**RE: SCHIFFER BUILDING (C18-D26). ENGINEER'S CERTIFICATION FOR
CERTIFICATE OF OCCUPANCY APPROVAL. ENGINEER'S CERTIFICATION
STAMPED 6-4-96.**

**RE: SCHIFFER BUILDING (C18-D26) DRAINAGE PLAN AND WORK ORDER
DRAWINGS FOR BUILDING PERMIT APPROVAL. ENGINEER'S STAMP
DATED 12-12-95.**

SUPPLEMENTAL CALCULATIONS
FOR
SCHIFFER BUILDING

**RE: SCHIFFER BUILDING (C18-D26) DRAINAGE PLAN FOR SITE
DEVELOPMENT PLAN FOR BUILDING PERMIT APPROVAL. ENGINEER'S
STAMP DATED 10-20-95.**

POND OUTLET

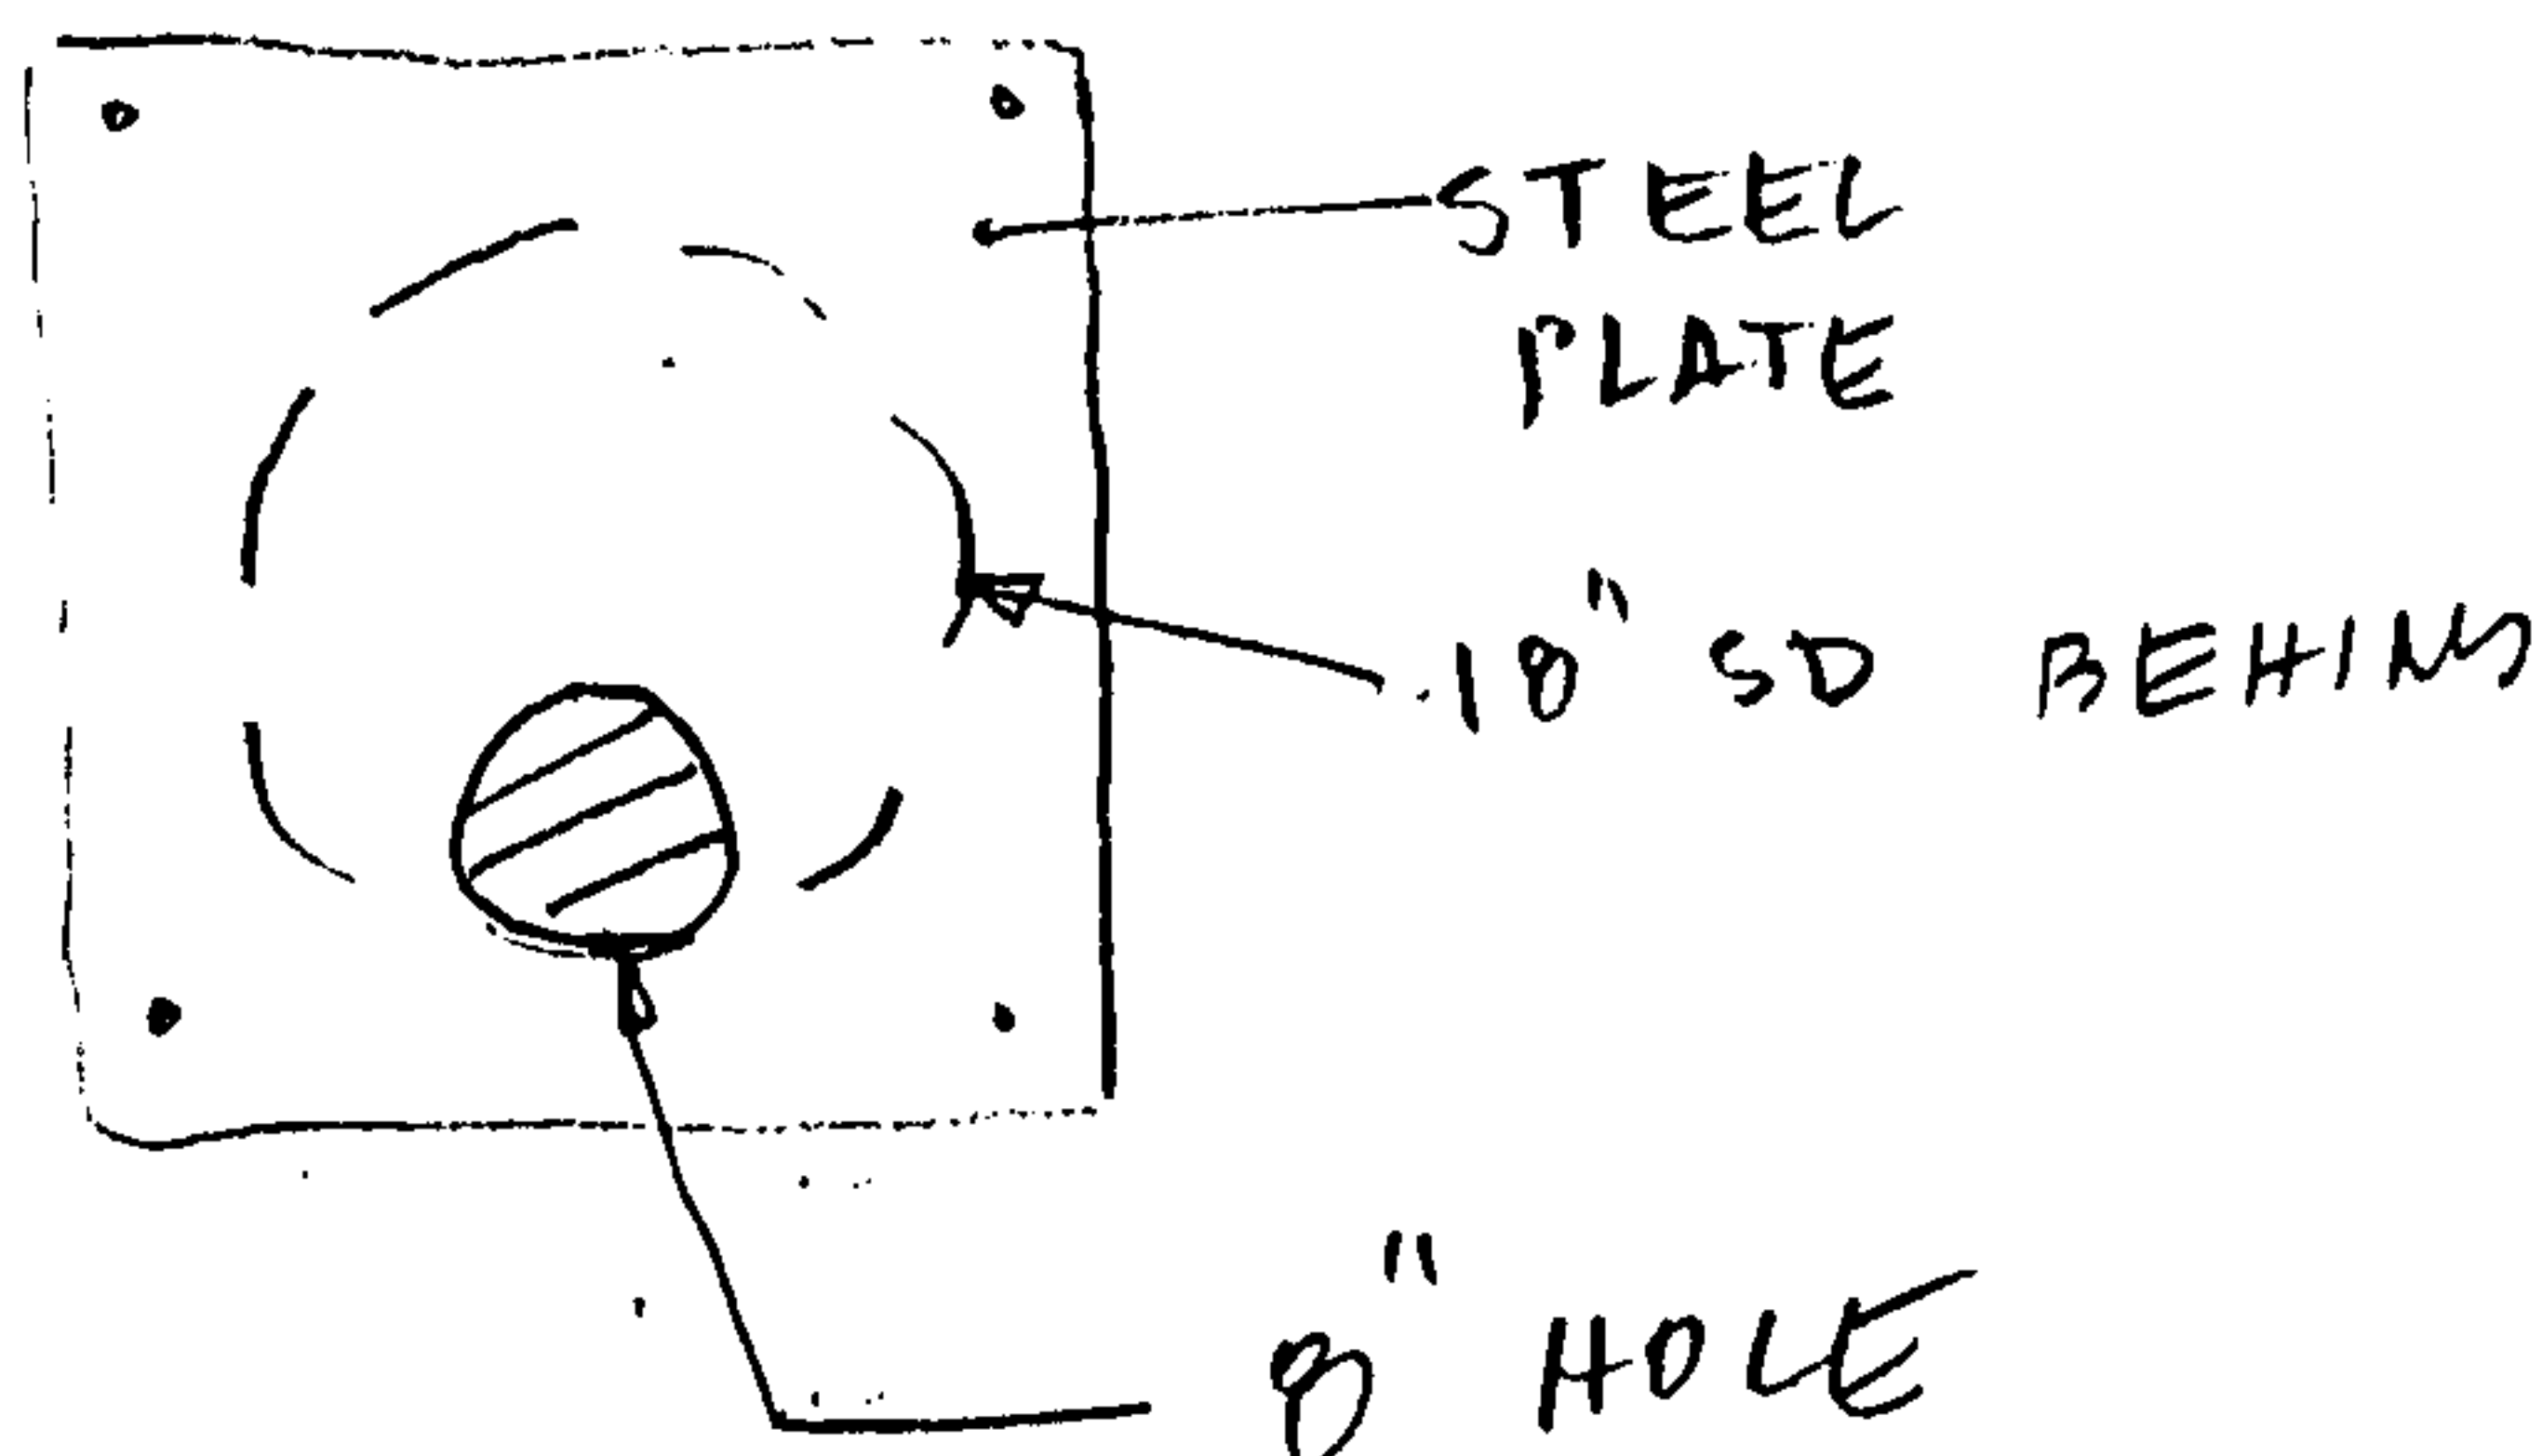
My letter dated November 7, 1995 suggests the use of a type "A"
inlet instead of a type "D." This design suggestion, as you
pointed out, was not possible. Sorry about that. The City has
been informed of numerous maintenance problems (clogging) with
the type "D" inlet. While I understand that the maintenance of
the pond and the inlet are the owners responsibility and not the
City's, I thought it wise to inform you of the problems occurring
with this type of inlet. If at all possible, you may want to
consider another type of inlet.

1. Determine allowable discharge from your site to the existing 30" storm sewer in Signal Ave. Is there capacity to discharge 2.95 cfs into the existing storm sewer line?
2. You will be required to install a manhole where you tie into the existing 30" storm sewer.
3. Please give a minimum cross slope for your channel along the west property line.
4. Your details are numbered incorrectly. There are two detail "A's" and two detail "B's."
5. Is south side of Signal Ave. paved? Please label on your detail.
6. Past experience shows that type "D" inlets clog very easily. A type "A" inlet is more desirable.
